BY-LAW NUMBER 2007/21

(a) The document attached to this By-law as "Appendix A", together with accompanying maps, is hereby adopted as the "*Bridges Area Structure Plan, NE 22-46-6-W5M, Plan 7823341, Block 2, Lot 1*".

AREA STRUCTURE PLAN (ASP)

Block 2, Lot 1, Buck Lake Estates Plan 782 3341

Drainage Concept Plan, Scale 1:2500

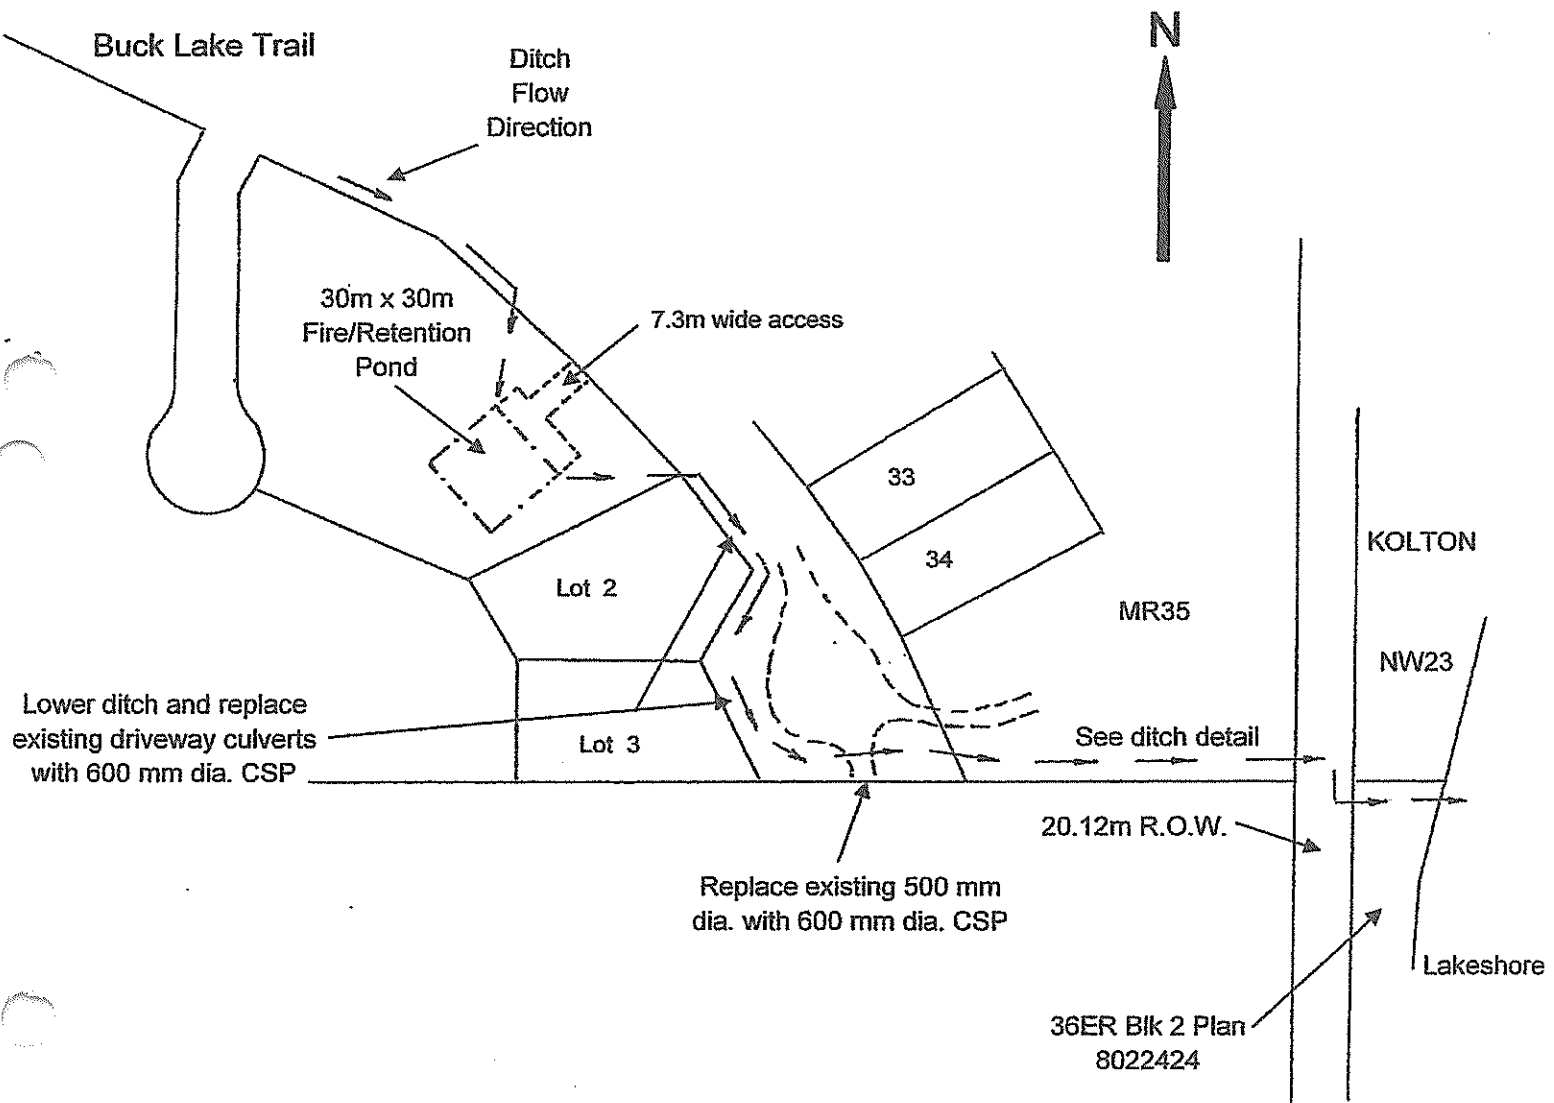
EXH Engineering Services Ltd. (EXH) has reviewed the revised information provided for the stormwater management plan for this proposed subdivision and has the following comments:

- 1) We recognize that the information submitted is conceptual in nature and therefore would not have the required detail to fully or adequately review the proposed system. The plan provides a conceptual basis for the proposed system and as such the amount of detail provided is adequate. The overall concept appears feasible subject to further detailed engineering. Further detailed engineering would be required to be submitted and properly reviewed before any approvals are issued for construction of the works.

- 3) Further details on the ditch gradients and culvert inlets/outlets to Buck Lake should be included in the detailed design.
- 4) The further engineering details must be presented in a report/letter format with accompanying plans. The report and plans must be signed by a professional engineer registered with APEGGA.

The Developers will provide an additional detailed storm water management plan showing all ditch gradients and culvert inlets/outlets to Buck Lake and will be submitted and signed by a professional engineer registered with APEGGA, and will be provided to County Officials at the time of construction of the subdivision. Alberta Environment has been contacted and they welcome additional quality runoff water into Buck Lake. The Developer ensures all construction will comply with County Standards, Alberta Environment guidelines and all approvals.

PLAN SHOWING DETAIL OF FIRE POND FOR PROPOSED 18 LOT SUBDIVISION OF LOT 1, BLOCK 2, PLAN 37823341

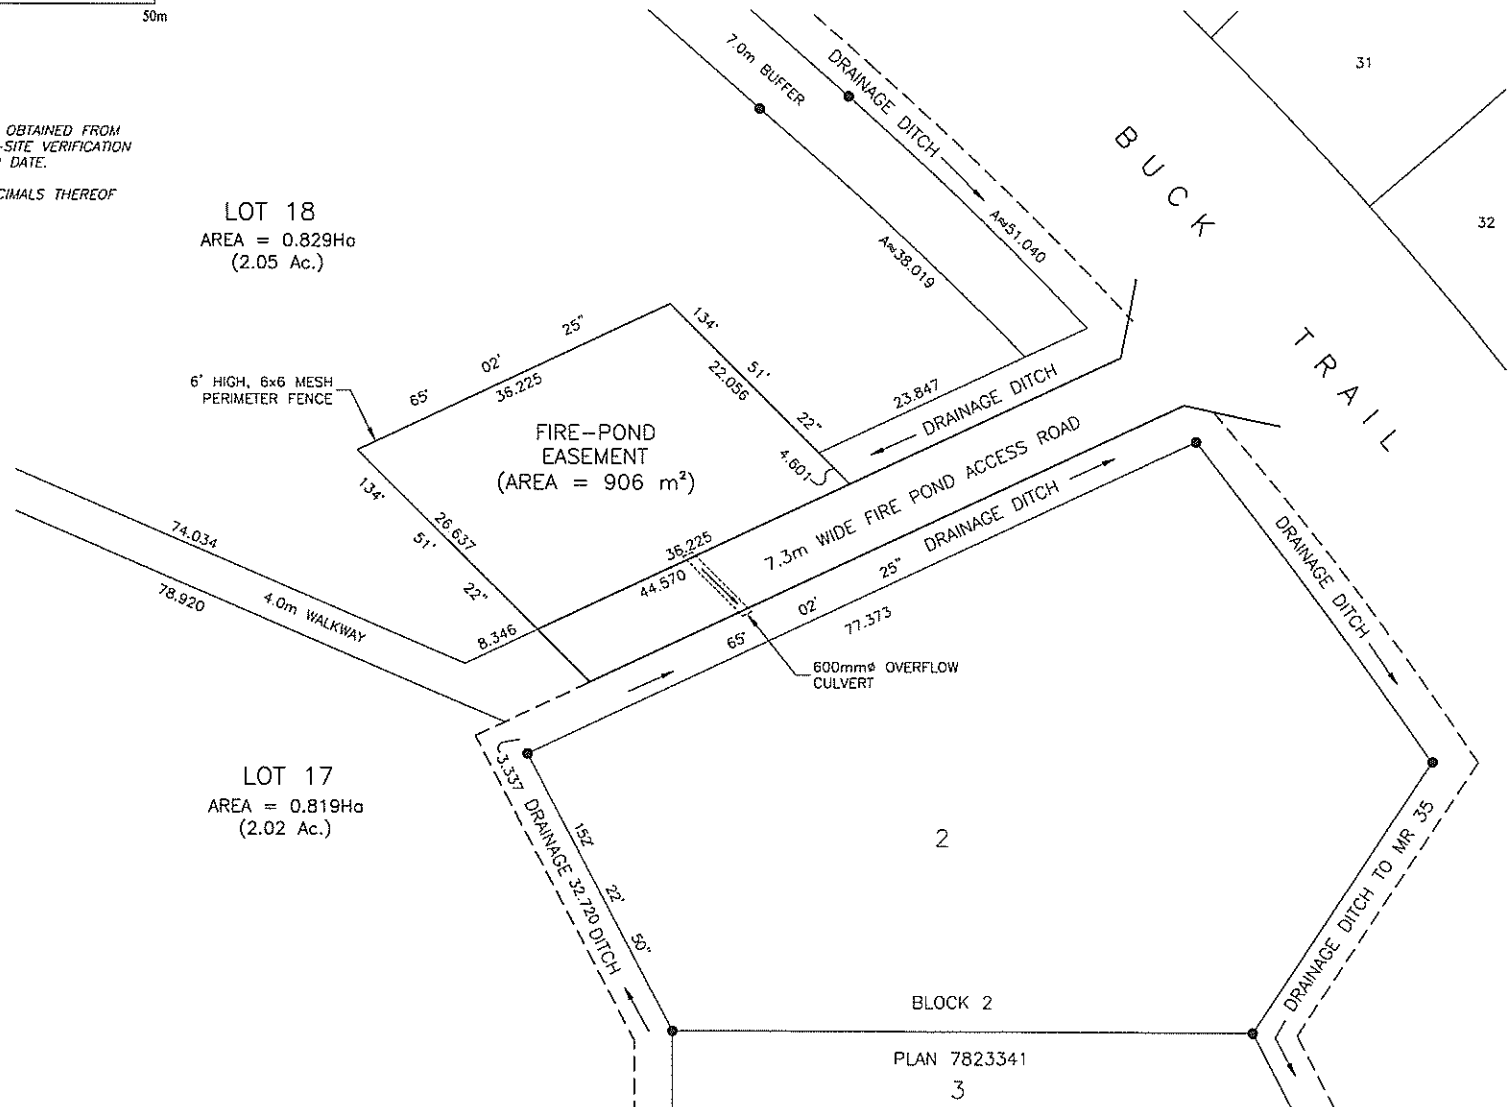
4: After reviewing the drawing plan 37823341 it shows the (fire pond) in Lot # 18. This is completely unacceptable. This Lot is heavily treed. Meaning much of the lot would have to be cleared to build and have water drain into it. The pond would be of no service to the proposed subdivision. As there is no access for a fire water truck to take on water. The only way that could be accomplished is to build an approach off of Buck Lake Estates road. At the far end of the proposed subdivision completely out of the question! Further more it would be a breeding grounds for mosquitoes.

5: I propose a remake of the proposed subdivision access. Move the road down to the West End around Buck Lake Estates Lots #8, #9. See drawing attached the fire pond could be relocated in or around Lots #7 #15 putting the pond in the middle of the proposed subdivision. Placing the pond here no trees would have to be removed. Also in moving the road there would only one approach instead of two and the fire pond accessed making three. One service road is a lot safer this would also cut down the amount of traffic; using three quarters of the Buck Lake Estates road Lot#1 to Lot#34.

Developer will provide a fire pond to specifications and satisfaction of the County Fire Chief. The specifications for fire pond as provided by the County Fire Chief - Ken Carlson will contain 4000 gallons per lot x 18 lots = 72,000 gallons plus allowance for 3 feet of frost top for approx 100,000 gallons winter storage. The fire pond will be setback a minimum 30 meters from road allowance and a minimum 6 meters from adjacent property lines. All season 7.3 meter road top, with road access easement for the fire dept will be provided. The fire pond will be on a public utility lot – county owned. Fire pond location is shown at the east end on lot 18 of the proposed design. The fire pond / storm wet pond will be fenced with a 6 x 6 mesh wire fence, 6 feet high with appropriate signage.
